NPL 2000-0411

DOCKETS 50-266 AND 50-301
SUPPLEMENT 6 TO APPLICATION FOR AMENDMENT TO
FACILITY OPERATING LICENSE APPENDIX A:
TECHNICAL SPECIFICATIONS IMPROVEMENT PROJECT
RESPONSE TO RAI ON ITS SECTION 5.5 (TAC Nos. MA7186 and MA7187)
POINT BEACH NUCLEAR PLANT, UNITS 1 AND 2

DOCKETS 50-266 AND 50-301
RESPONSE TO REQUEST FOR ADDITIONAL INFORMATION
TECHNICAL SPECIFICATIONS IMPROVEMENT PROJECT SECTION 5.5
POINT BEACH NUCLEAR PLANT UNITS 1 AND 2

5.5.11 Ventilation Filter Testing Program (VFTP) (continued)

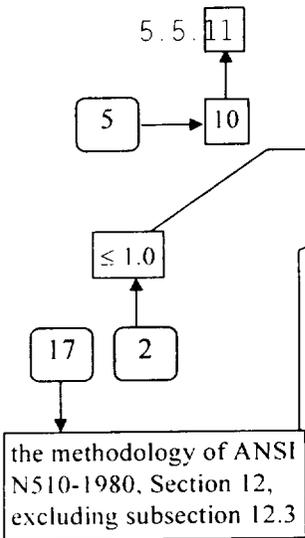
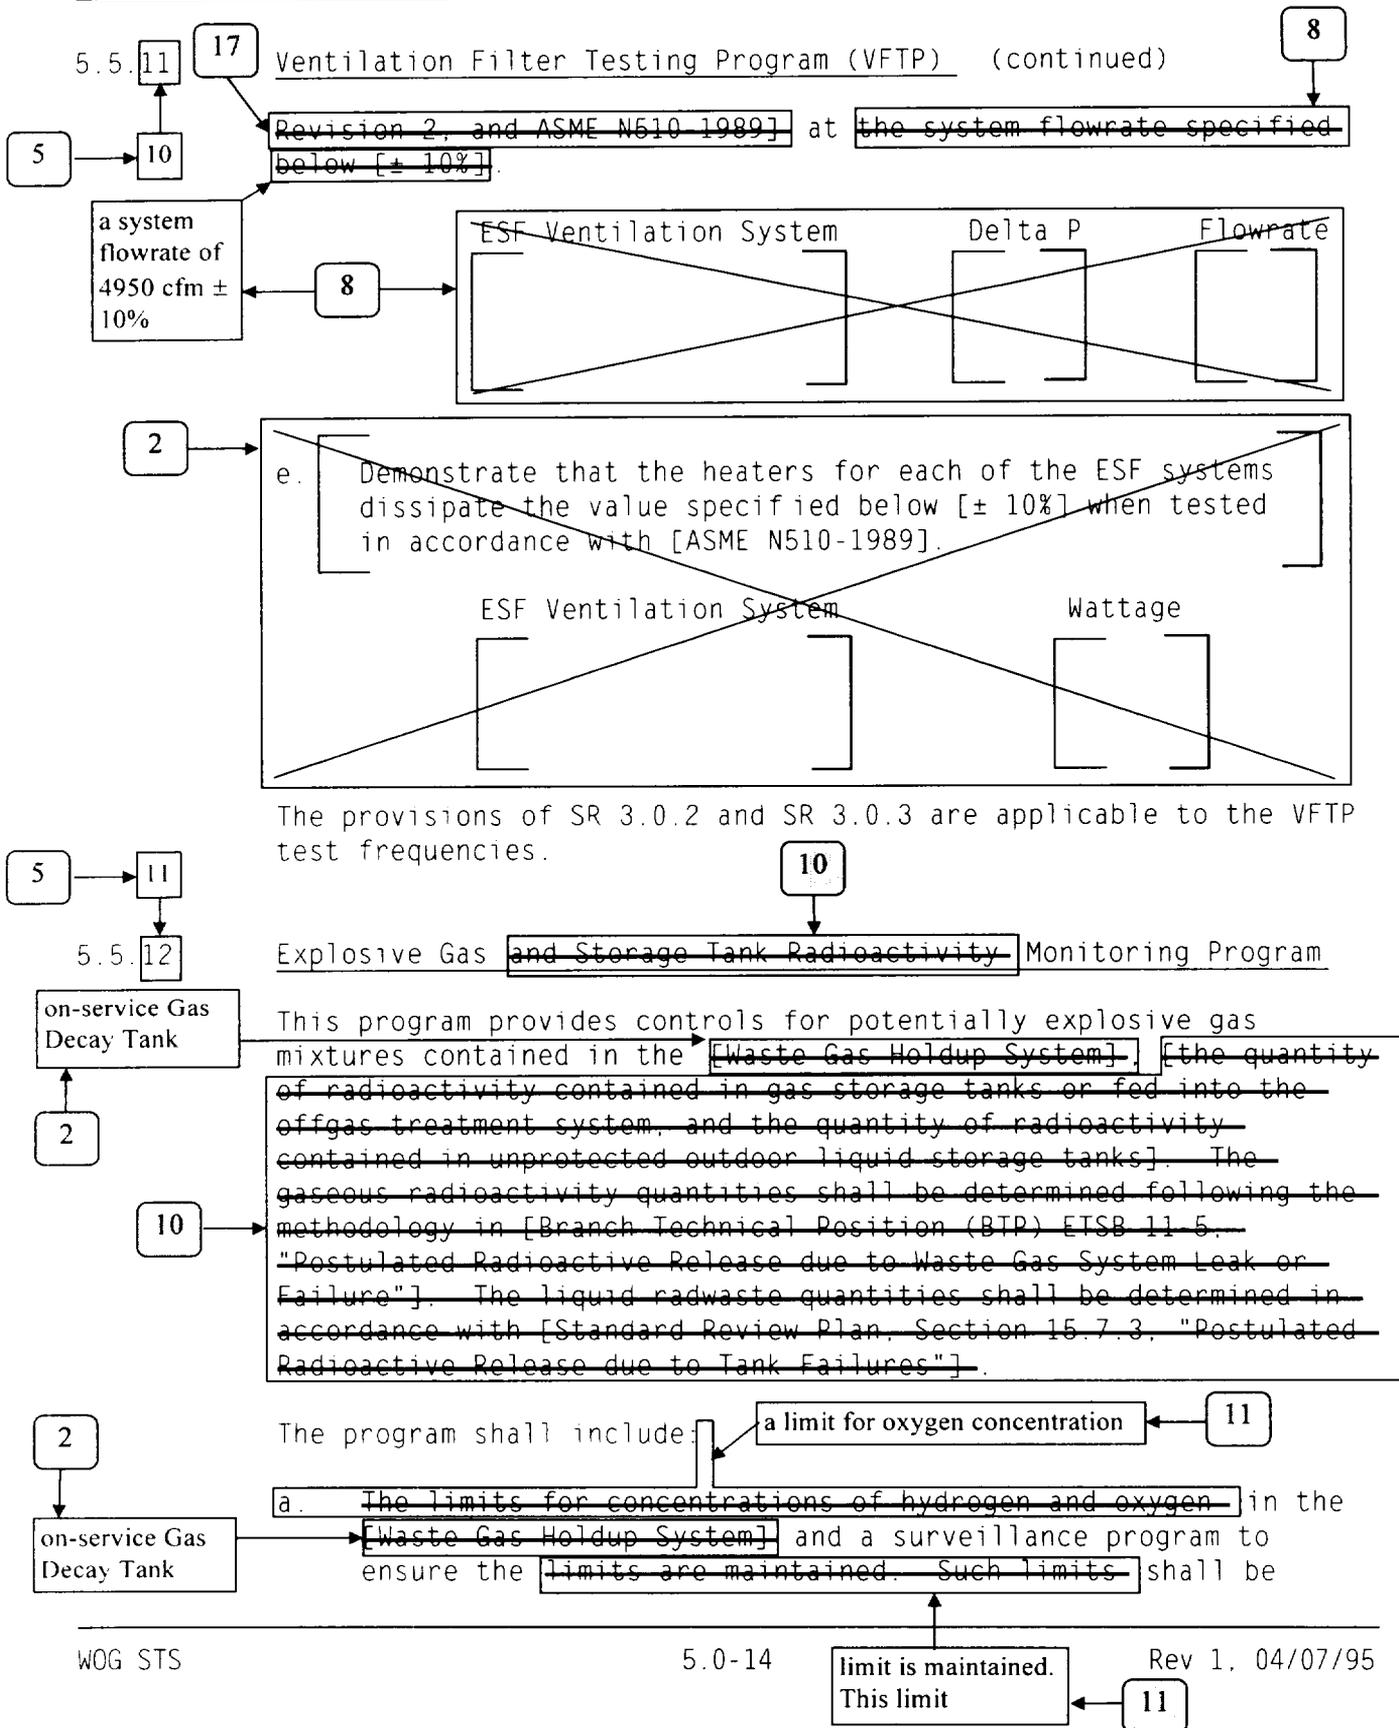
There is a discrepancy between the Section 5.5 mark-up and the proposed final draft. The mark-up references ASME N510-1989 and the final draft references ASME N510-1980. Which version will be used for the final draft? If exceptions are taken, explicitly state those sections.

The Section 5.5 mark-up says, "the applicable portions of Regulatory Guide 1.52, Revision 2." This vague terminology is unacceptable. However, the Section 5.5.10 final draft does not contain this vague terminology. Does the final version have exceptions to Regulatory Guide 1.52 or the ASME or ASTM codes? If so, explicitly state those exception sections.

The proposed final draft Section 5.5.10, first paragraph, should add the "ASTM D3803-1989" at the end of the sentence for consistency. Will this be added?

The proposed final draft Section 5.5.10.c should remove the " \leq " before 30 degrees Centigrade and remove "greater than or equal to" before relative humidity for consistency. Will these be removed?

Corrections have been made to ITS Specification 5.5.10 to indicate the Control Room Emergency Filtration System will be tested in accordance with the methodology of ANSI N510-1980, Sections 10, 12 and 13, excluding subsections 10.3 and 12.3, as applicable. Discrepancies between the markups and the proposed final draft have also been resolved.

Corrections have been made to ITS Specification 5.5.10 to indicate the Control Room Emergency Filtration System will be tested at the frequencies specified in Regulatory Guide 1.52, Revision 2, and in accordance with ASTM D3803-1989 and the methodology of ANSI N510-1980, Sections 10, 12 and 13, excluding subsections 10.3 and 12.3, as applicable. Discrepancies between the markups and the proposed final draft have also been resolved.

ITS Specification 5.5.10 has been revised to indicate the Control Room Emergency Filtration System will be tested in accordance with ASTM D3803-1989.

The proposed final draft Section 5.5.10.c has been revised to more closely reflect the requirements of ASTM D3803-1989. The inequalities preceding the temperature and relative humidity values have been deleted and the phrase, "applying the tolerances of ASTM D3803-1989" has been added to the end of the last sentence.

the methodology of ANSI N510-1980, Section 12, excluding subsection 12.3
in accordance with the methodology of ANSI N510-1980, Section 13, excluding subsection 12.3.

applying the tolerances of ASTM D3803-1989.
